Consultation

Isle of Skye project - Initial Needs Case consultation

Publication date: 16th Dec 2021

Figure 2: Existing Skye 132kV Transmission Network and proposed reinforcement¹³

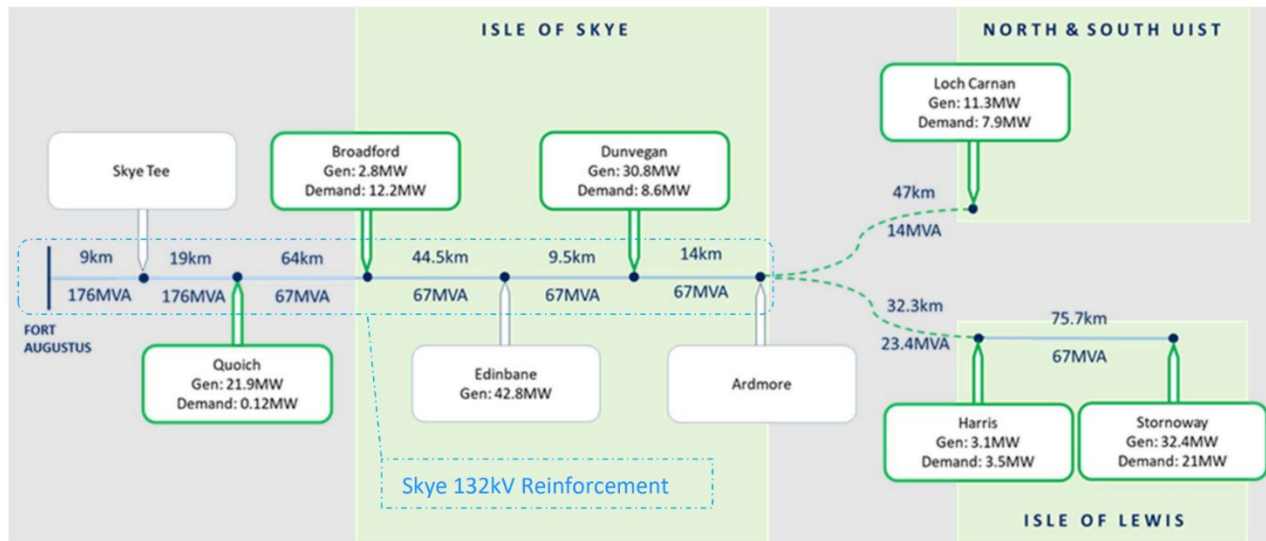
2.30. We agree with SHET that the Skye project has several clear asset health drivers requiring intervention. The evidence presented within the INC, along with further questioning and viewing the assets in person, has clearly established the need for asset intervention.

2.32. We do not entirely agree with the security of supply driver put forward by SHET.

2.33. From a demand perspective, Skye is currently secured by several diesel generator sets and from the distribution network. When the existing Skye 132kV circuit is on outage or faults, the demand is collectively met by the distribution system and the embedded diesel generators. The diesel generation located on the Western Isles is used as standby generation in the event of a single circuit fault on the transmission system. As there are no plans to remove any of the diesel generator sets from the distribution network, regardless of which Skye option is selected, the demand is currently secure. However, we recognise that in the case of a fault or outage, there are higher costs both financially and environmentally with the

Figure 3: Five shortlisted options

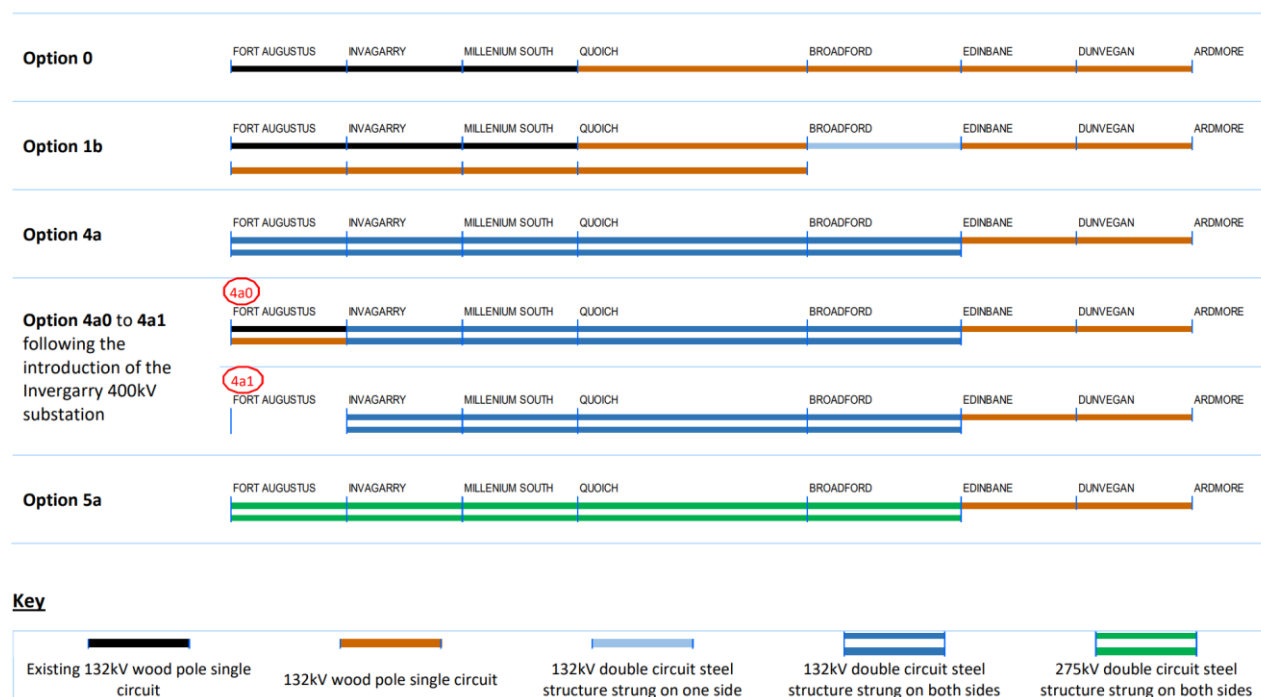
2.35. We deem that an appropriate range of options were considered to address the non-load and load related drivers for the Skye project, noting that all options provide a SQSS compliant solution. Throughout the optioneering process several designs were considered and rejected. We reviewed the technical solutions presented and found them to be appropriate. We recognise that the current costs are indicative but consider these costs to provide an appropriate basis under which to robustly compare the options at this stage. Overall, we are comfortable with the options taken forward for assessment in terms of their technical solution.

2.37. Option 0 is a single circuit trident 132kV wood pole and represents the cheapest option. Although this option does increase the overall intact rating over the existing Skye 132kV circuit, we agree that it does not provide enough electrical transfer capability when considering potential future generation wishing to connect to the Skye network. Furthermore, this option does not improve transmission access or resilience as this is a single circuit design.

2.38. Option 1b is a combination of double and single circuit sections. The transmission access or resilience is improved in comparison to option 0 for the sections between Fort Augustus and Broadford; however, a single circuit outage on the double circuit section may still not provide enough electrical transfer capability as this would depend on the level of potential generation that comes forward.

2.39. Option 4a would address both the non-load and load drivers. Furthermore, based on stakeholder feedback gathered by SHET, this design represents the maximum environmental impact stakeholders, including the planning authorities, may be willing to accept on Skye. This is mainly a problem where steel towers will replace wood poles: 132kV steel towers are 40-50m in height whereas wood poles are 10-14m, with stakeholders noting that steel tower structures would have a detrimental visual impact on the picturesque surroundings and possibly affect the local wildlife. Engagement with statutory consultees, landowners, and others highlighted the sensitivity and potential risk of gaining planning consent.

2.40. Option 4a01 is, from a design perspective, similar to option 4a and can provide the same power transfer capability albeit at an increased cost to the consumer.

2.41. Option 5a, the 275kV design solution, would address both the non-load and load drivers. The capacity of the design by virtue of the increased conductor rating exceeds the level of generation that is currently contracted. However, if significant future levels of generation come forward beyond those levels currently contracted, then option 5a would enable an amount of higher generation transfer scenarios to be met. This option would however exacerbate both technical and planning consent challenges. Technical challenges relate to the construction phase as access in some areas is extremely challenging. In terms of consent, as stated above, where steel towers replace wooden poles there is an elevated risk of not receiving planning consents. Finally, this option would incur the most cost to the consumer when compared to the other options and would also extend the delivery date by a further two years leading to longer time frames before any additional generation could connect to the Skye network.

2.48. Overall, we consider that the preferred option put forward by SHET (option 4a or 4a01) is reasonable and is likely to provide the optimal solution given the combination of non-load and load related drivers, and the background generation assumptions that underpin the CBA.
